ADA Compliance Program

Clark County Facilities Transition Plan Public Works Operations Center

Date of Survey: November 5, 2007 and December 6, 2007

Fig. 604.5.1
 Side Wall Grab Bar for Water Closet

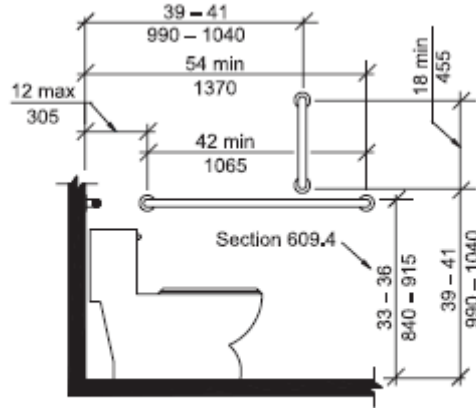
Item # 9
 Issue: Vertical Grab Bars
 Issue: Forward Reach
 Issue: Flush Controls
 Issue: Clear Floor Space
 Location: Conference Center
 Code: ANSI 604.5.1 – Vertical Grab Bar

Code: Issue: Flush control location in SW restroom
 ANSI 604.6 Flush Control – Flush controls shall be hand operated or automatic. Hand operated flush controls shall comply with Section 309. Flush controls shall be located on the open side of the water closet.

Forward reach height of the towel dispensers is currently 56 inches high. Toilet seat cover dispenser height is currently 49.5" high in the SW restroom.

Access blockage due to stored items - Remove items from NW restroom

Code: ANSI 308.2 Forward Reach – 308.2.1 Unobstructed – Where a forward reach is unobstructed, the high forward reach shall be 48 inches maximum and the low forward reach shall be 15 inches minimum above the floor. All dispensers should be checked for correct height installation and lowered as needed.
 Recommendation: Lower dispensers per ANSI code.

Place flush control on open side of toilet in SW restroom.
